Re: Spill Prevention Control and Countermeasure Plan

SPCC #C94028

RE: LETTER OF VIOLATION Issued Pursuant to Oil Pollution Prevention Regulations Promulgated Spill Prevention, Control and Countermeasure (SPCC) Number: C94028

# **Spill Prevention Control** and Countermeasures Inspection

South Tank Farm

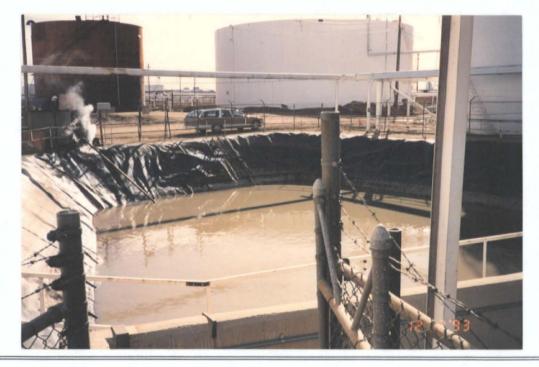
- <u>Facility drainage undiked areas [112.7(e)(1)(iii)]</u>: Inadequately addressed. There is no discussion regarding the stormwater retention ponds located south of the south tank farm. The ponds are not indicated on the facility diagram.

Railcar Loading Area - Diesel Rack

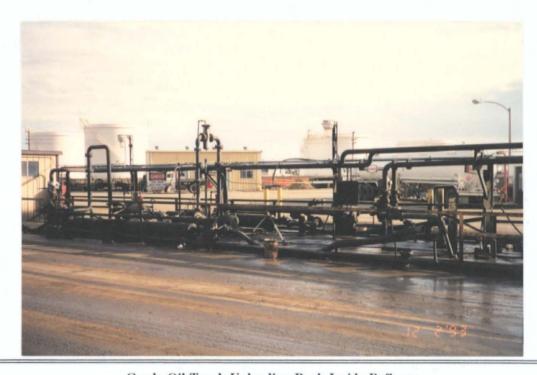
- <u>Loading/unloading operations containment for railcars [112.7(e)(4)(ii)]</u>: The railcar loading/unloading area containment system is not addressed.
